Certificate of Appropriateness Case Report

Filing Date: March 25, 2014
Case No.: **2014.0425A**
Project Address: **981 Grove Street**
Landmark District: Alamo Square
Zoning: RH-2 (Residential, House, Two-Family)
40-X Height and Bulk District
Block/Lot: 0803 / 024
Applicant: William Duff Architects
26 O'Farrell Street, 2nd Floor
San Francisco, CA 94108
Staff Contact Alexandra Kirby - (415) 575-9133
alexandra.kirby@sfgov.org
Reviewed By Tim Frye - (415) 575-6822
tim.frye@sfgov.org

Certificate of Appropriateness Hearing
 Case Number 2014.0425A
 981 Grove Street
 Block 0803 Lot 024

Sheet Title
PROPOSED SITE PLAN

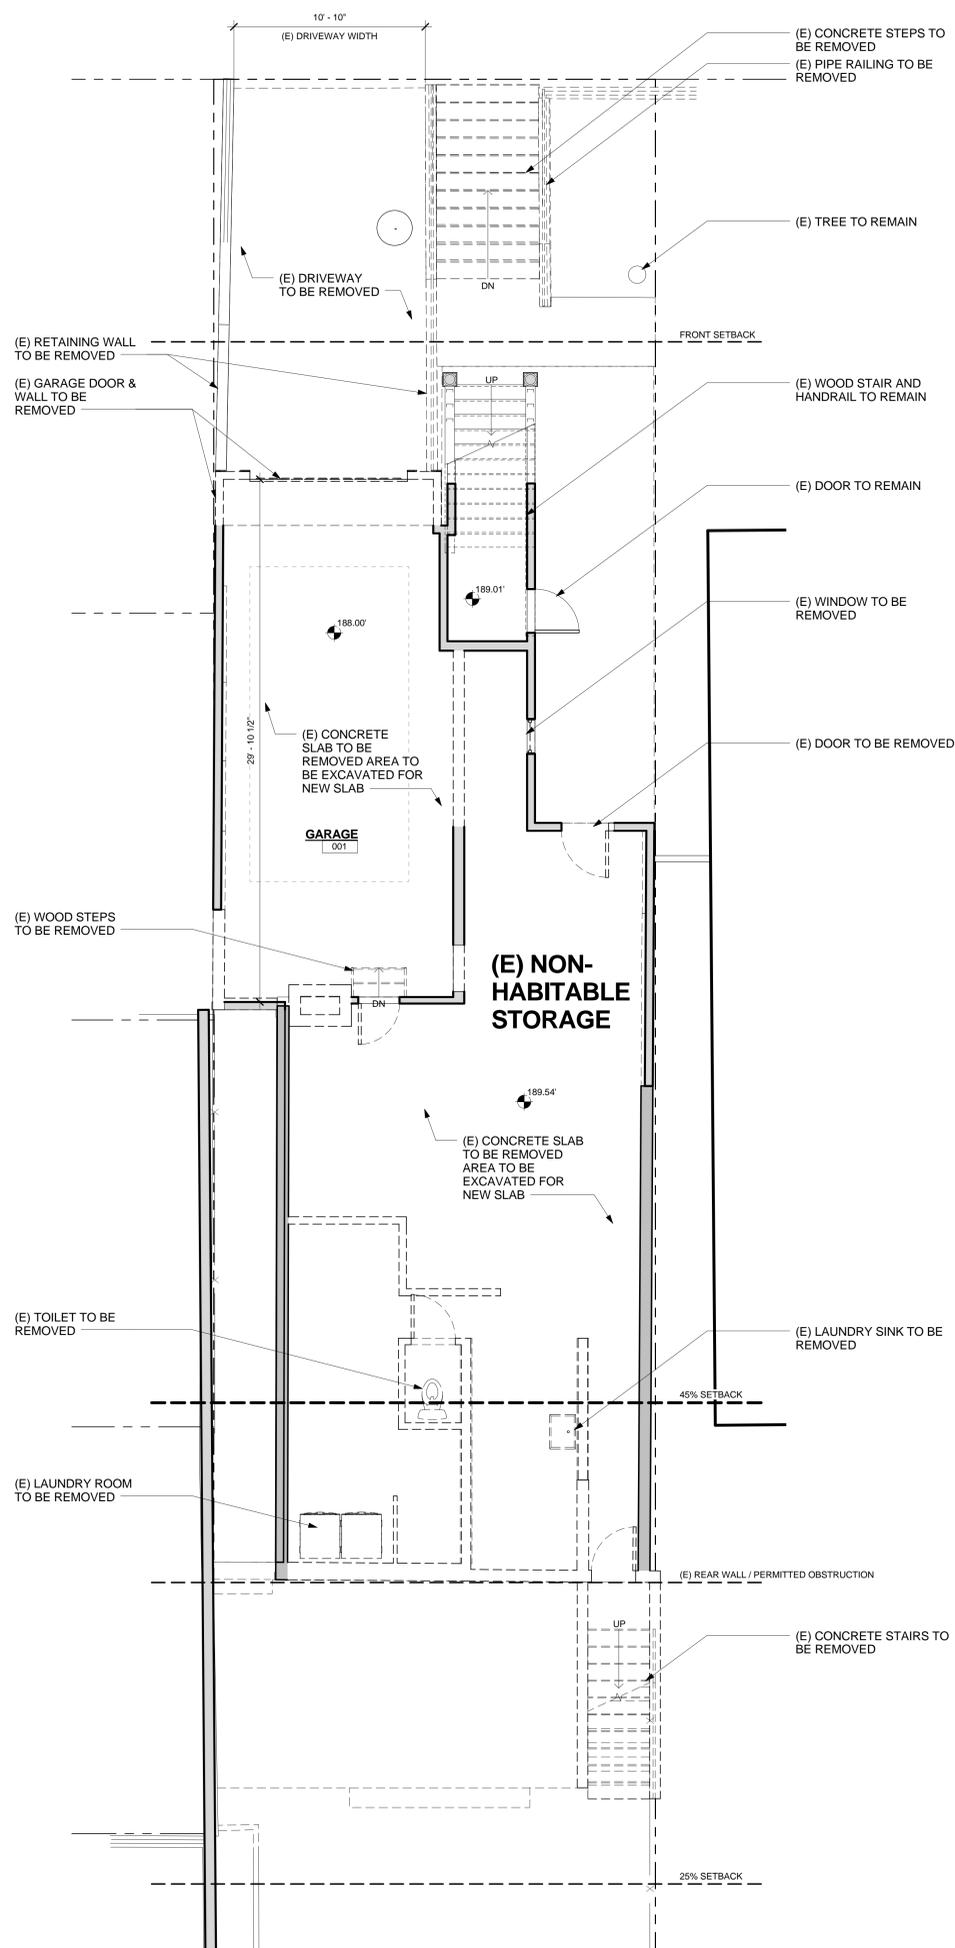
Staff finds that the proposed work to the retaining wall and the installation of new wood railings and planters will complement the historic setting of the subject building. Staff recommends that the proposed straight run of the stairs be retained along the west side of the existing retaining wall to bring the design into closer conformance with the Secretary of Interior's Standards, the historic condition of the property, and with the recommendations of the Residential Design Team as a condition of approval. Staff finds the proposed return on the stair to be in keeping with the character of the surrounding district, which exhibits a variety of stair configurations depending on the topography. The designs of all of the landscape features and planters are in keeping with the character of the property and district. Staff recommends that reconstruction of the east retaining wall shall use a smooth concrete finish as a condition of approval.

- The project sponsor shall retain the existing eastern retaining wall along the driveway to preserve the character of the straight-run stair at the upper portion of the stair.
- The project sponsor shall use a smooth-finished concrete wall for the new retaining walls flanking the driveway.

Sheet Title
SOUTH ELEVATIONS

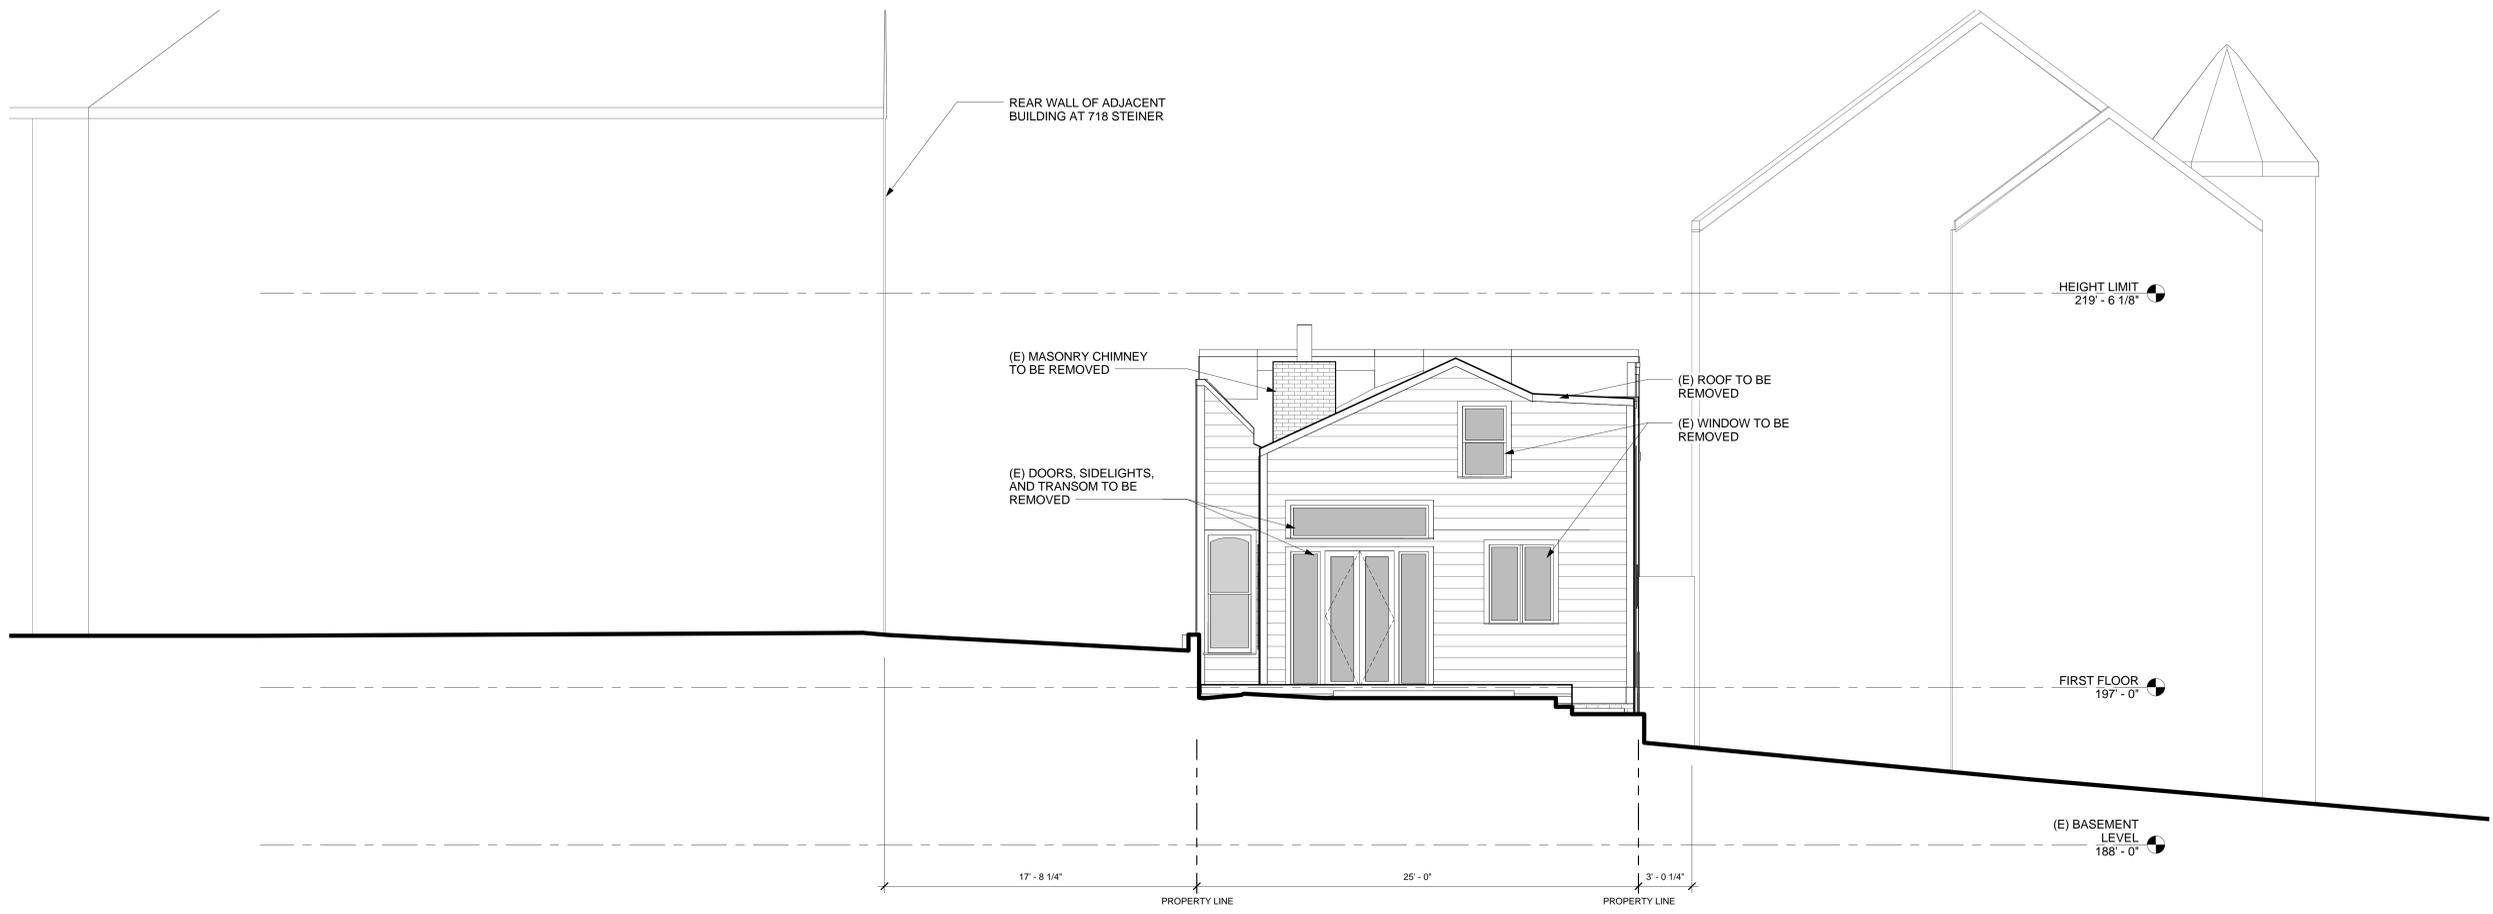
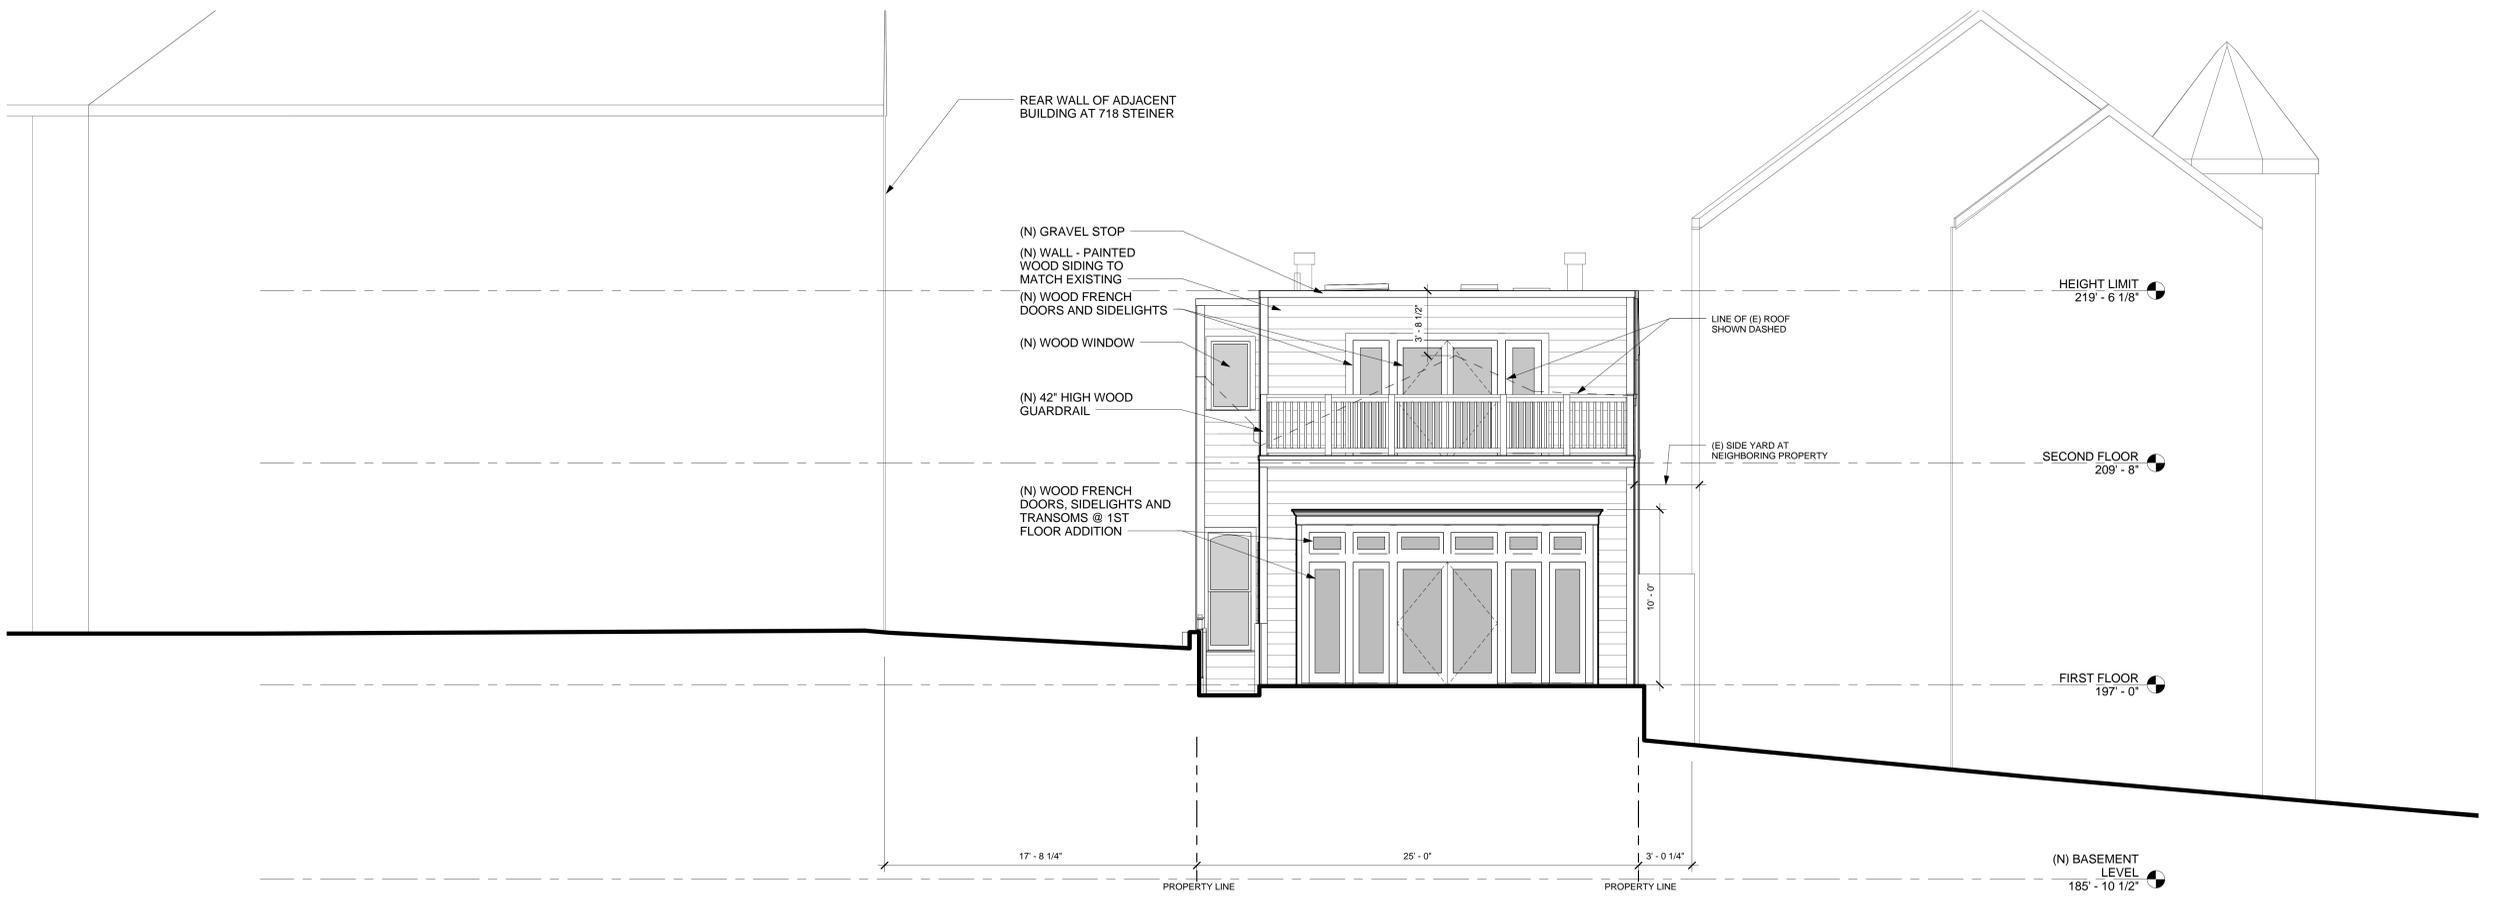
A deck, 8 feet, six inches deep, will be constructed above the first story at the rear (south) of the building, accessed via the new addition. The deck will feature a 42-inch high wood railing. The south elevation will feature horizontal wood siding to match the rest of the historic building, and two wood frame doors with a central lite will open out to the proposed deck. A fixed pane, wood frame sidelight will flank each side of the doors.

Staff finds that the proposed rear horizontal addition will not be visible from any public right-of-way. The mass, scale and location of the new addition is consistent and compatible with the rear additions found on contributing properties within the surrounding district. Further, this work will not affect any character-defining features of the subject property or surrounding historic district, since the existing deck is a non-contributing element of the subject property. The new materials specified for the rear addition will be in alignment with the district's character-defining features, which include wood siding and wood-sash French doors with transom lights.
